Olympic Forest Coalition

COMMENTS ON STUMPY'S RIDE TIMBER SALE 30-88353; FPA 2612041

Map 1. ...Stumpy's Ride units 1-4, year of stand origin, and NSO structural habitat.

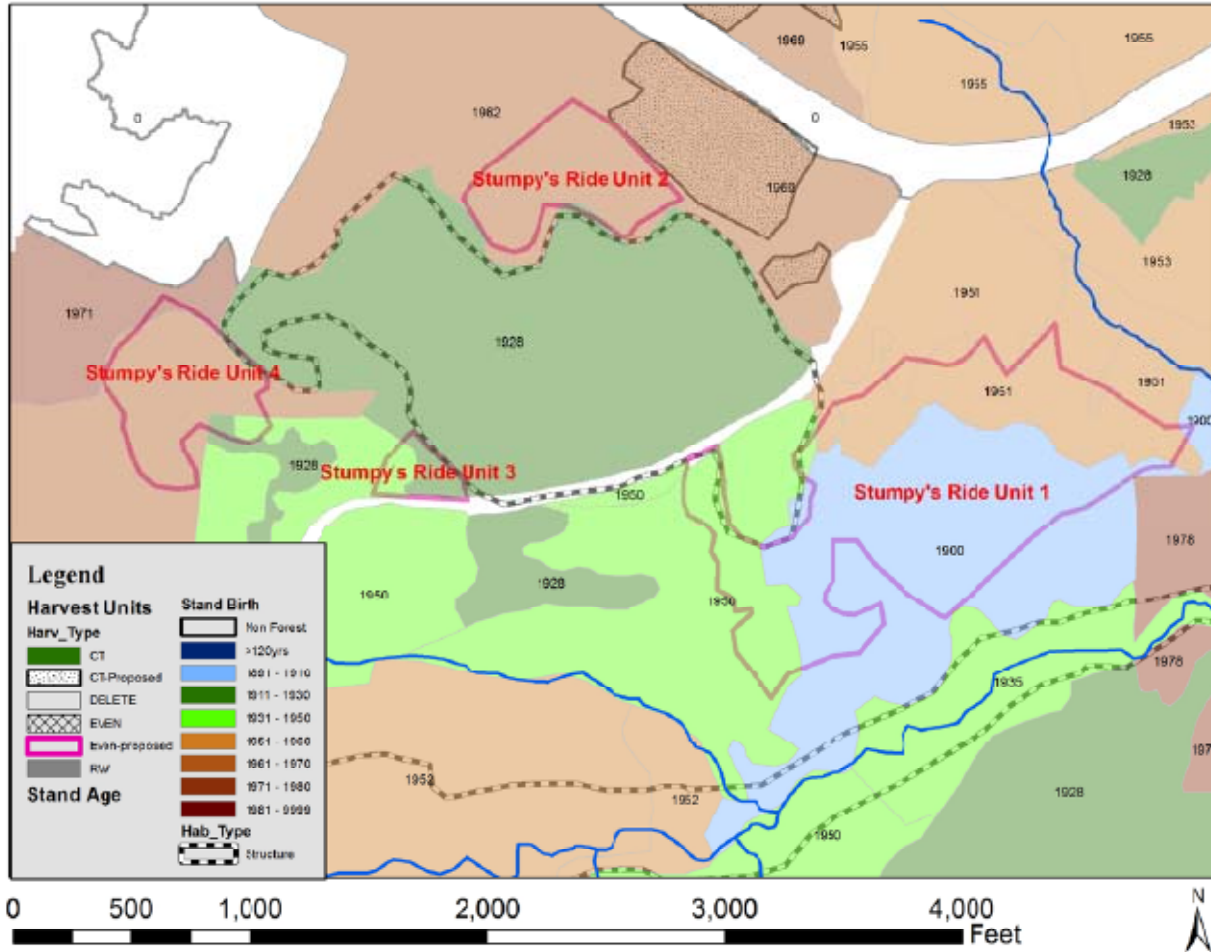
UNIT 1 HABITAT: See maps 1-4

OFCO's GIS work shows Unit 1 to be approximately 32.3 acres. Of that 18 acres are older forest (age unknown but inferred to be around ca. 1900). An additional 9.7 acres is from around 1951 (DNR mapped 1948); this is the area that shows a high density of larger, older trees in the 1957 aerial photo. All of this 9.7 acres is currently mapped as low quality adjusted habitat [MM science team database]. The remaining 4.5 acres is from 1950 (based on OFCO's Charley Creek stand age dataset). Please see Maps 1 through 4.

Unit 3: See map 1

This unit is small and it abuts mapped structural habitat. A little more than half of this unit was classified as having a stand birth date of 1928 (based on OFCO mapping). It is unclear how it was differentiated from adjacent structural habitat, or whether it should in fact be considered part of the adjoining stand.

Map 2. Stumpy's Ride Unit 1-4 on aerial photo, 1957

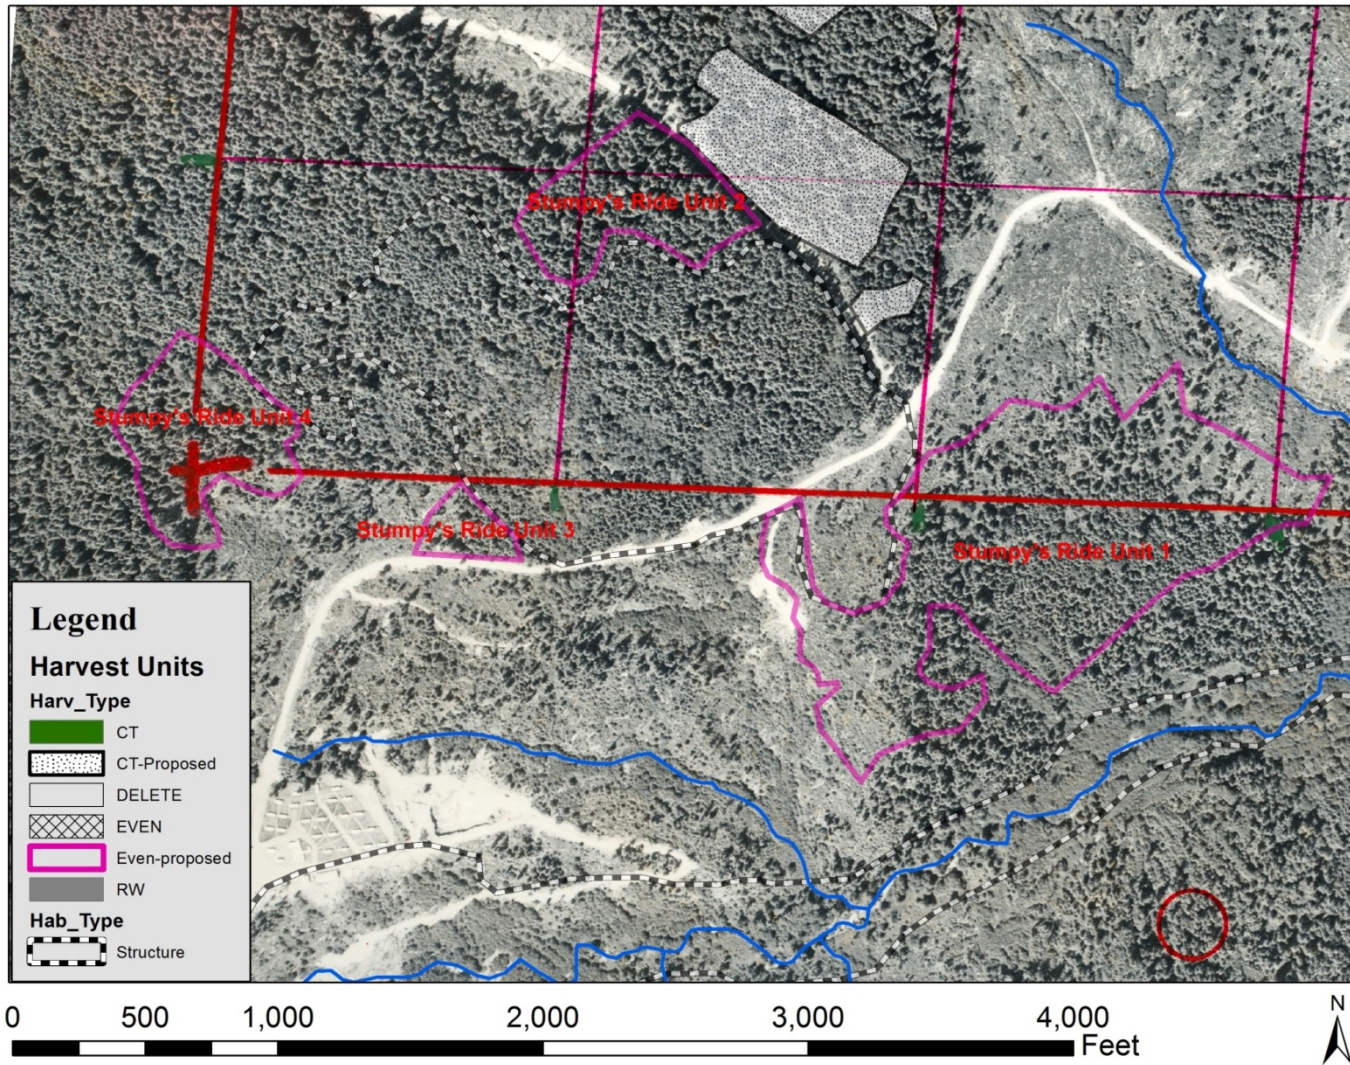
OFCO has found the habitat descriptions and/or mapping units are inconsistent with field and aerial photo evidence. The heart of the unit is a mature, old hemlock stand with no evidence of prior clear cutting. Substantial blocs of timber adjacent to the unit on the South and East have similar stand characteristics, except for having more old of other species than hemlock. These adjacent stands, as well as the leave trees within the unit, will be impacted by the increased exposure to wind, potentially resulting in windthrow following the harvest.

Map 3. Stumpy's Ride Unit 1 overlaid of 1957 aerial photo and MM habitat.

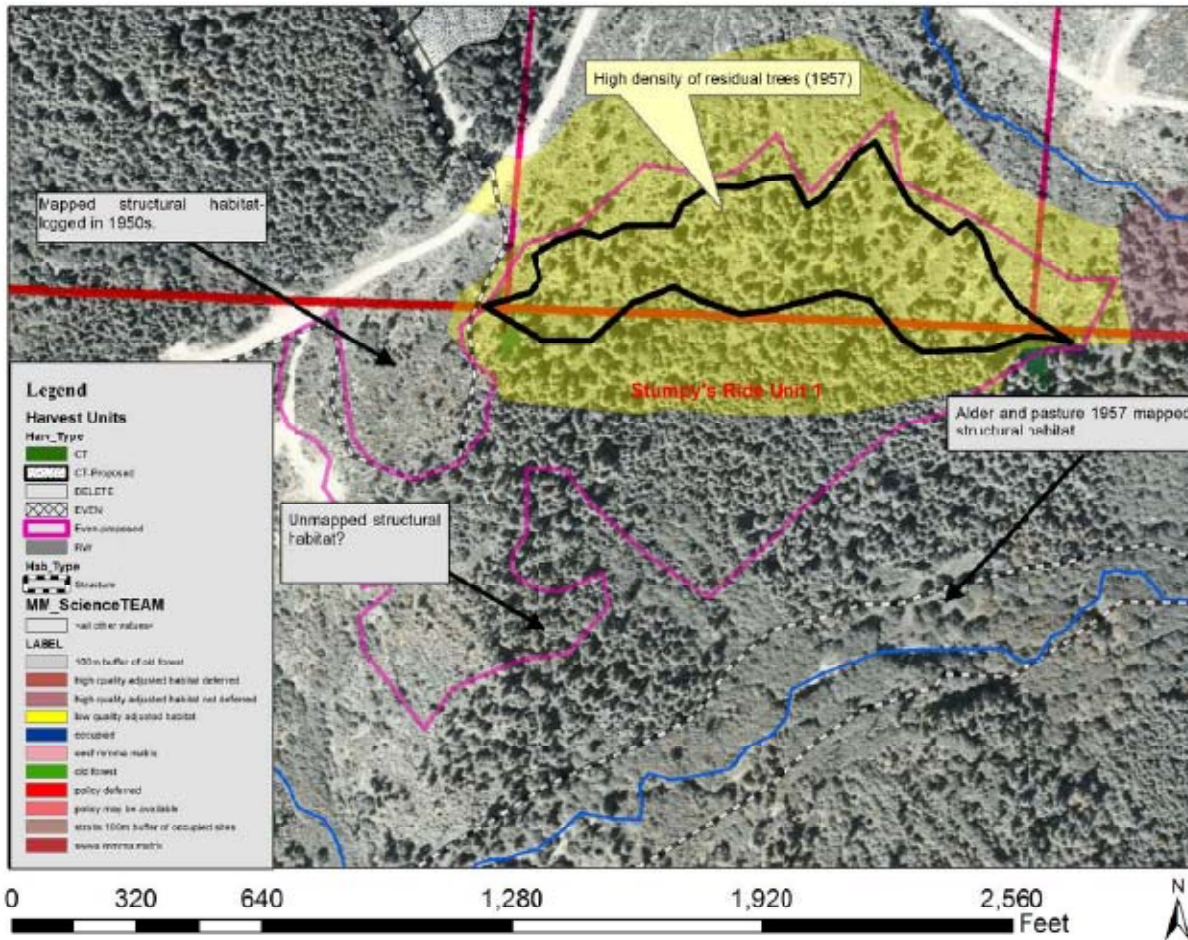
Unit 1 contains a significant amount of old, never harvested habitat, which is identified in the checklist as 112 years old. A substantial number of trees are significantly older than this. This stand may currently meet the requirements for marbled murrelet (MM) habitat or be close to it. It also may meet the requirements for northern spotted owl (NSO) habitat of some kind, or be close to it. If it is close, but lacking some characteristics on some acres, it becomes a good candidate for decadence work such as snag creation. A new inventory of the stand and its characteristics is needed to see, if it has reached habitat condition for MM or NSO or whether a decadence treatment would be needed to reach NSO habitat condition. These determinations are related to making a full and accurate implementation of the Settlement Agreement. If after a new inventory this unit is in fact at least Young Forest Marginal or better, it would require protection under PR 14-004-120.

Map 4 Stumpy's ride Unit 1 with Stand Birthdates.

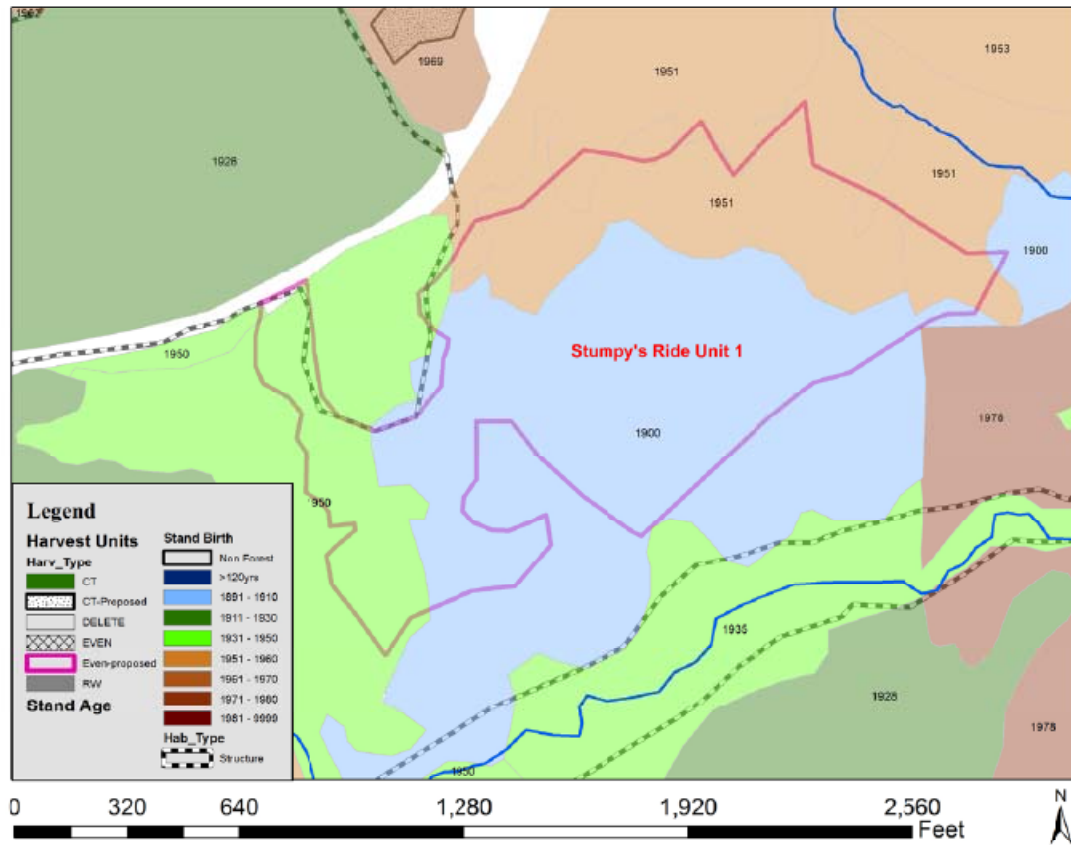
It is important not to regenerate this habitat and set the clock back 112+ or more years on this stand, at least until a new inventory is done and all other options are evaluated

Map 5. Big Country 2006 and adjacent structural habitat

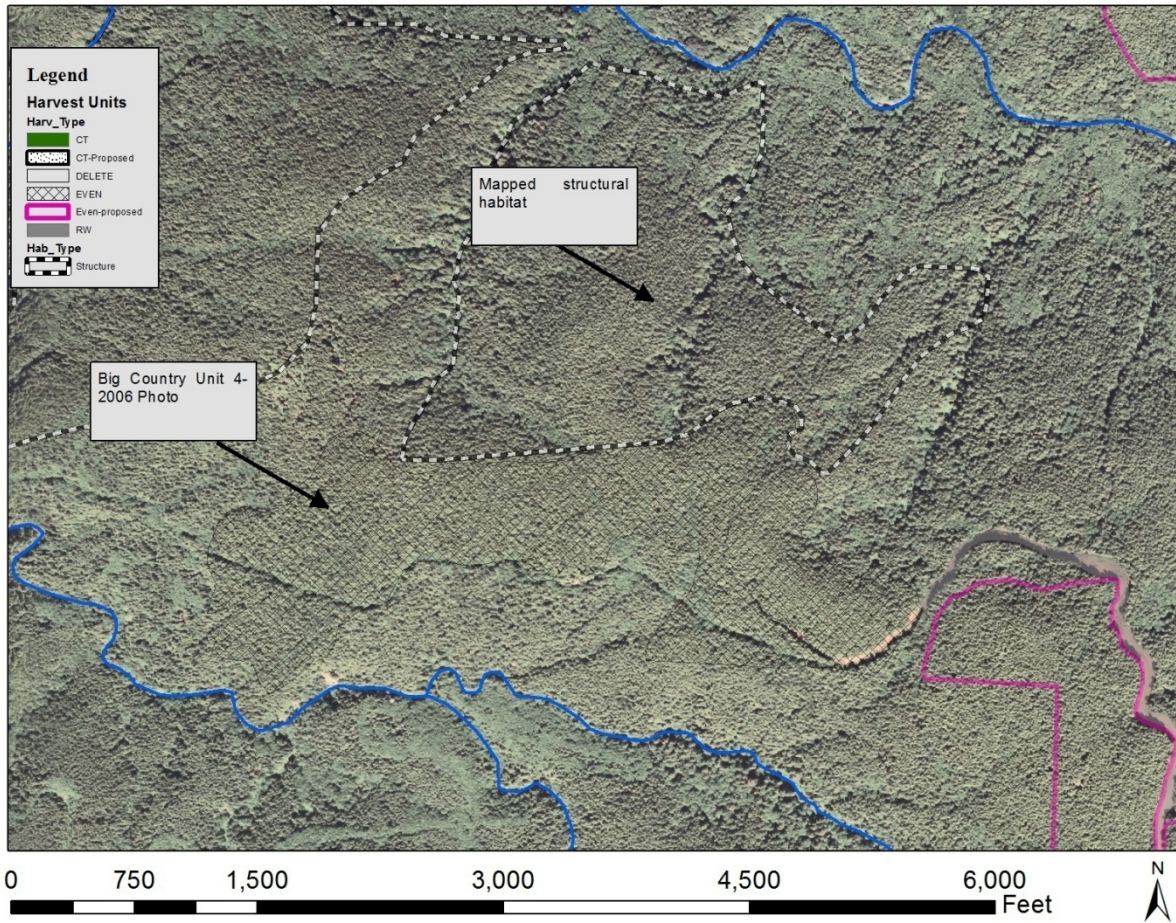
Another risk to MM and NSO habitat comes from locating regeneration harvests close to designated habitat.. There appears to be the potential of blow down on old habitat adjacent to Units 1, 2, 3, 4 and 5. A recent example of this is Big Country. Big Country included the regeneration logging of structural habitat which was then remapped to include non-structural habitat. It also involved massive blowdown of adjoining structural habitat, and potentially a second entry into structural habitat for salvage. There were huge direct and indirect habitat losses with this sale. Refer to blowdown risk under Unit 1 above.

Maps 6 & 7. Big Country 2011 and adjacent blowdown in structural habitat

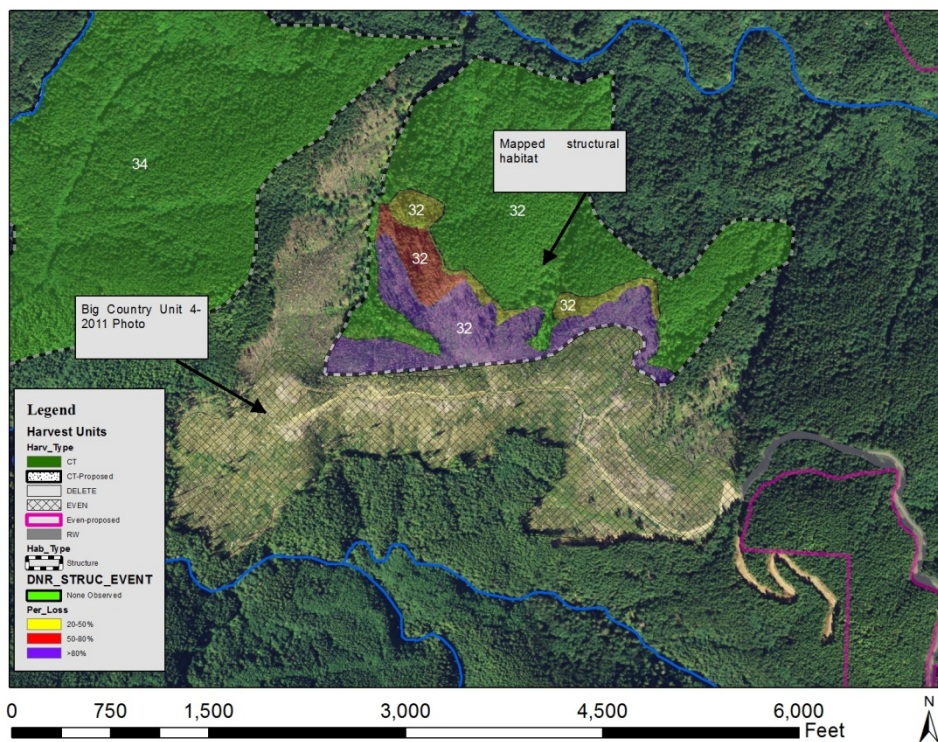
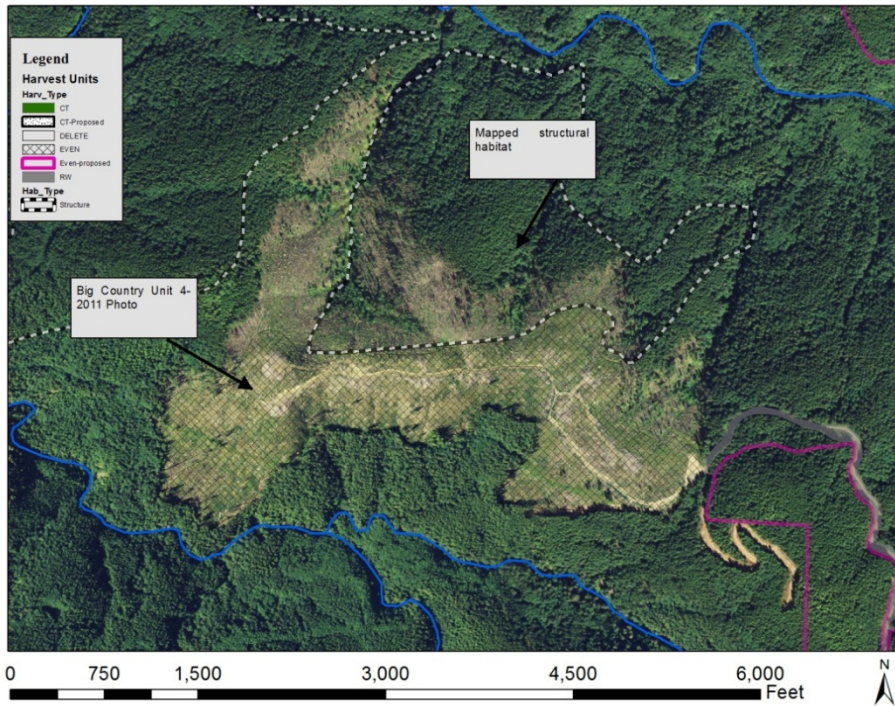
We are seeing blocks of habitat with regeneration harvest nearby. The currently existing Structural Habitat has lost an average of 15% due to blow down according to OFCO's analysis of
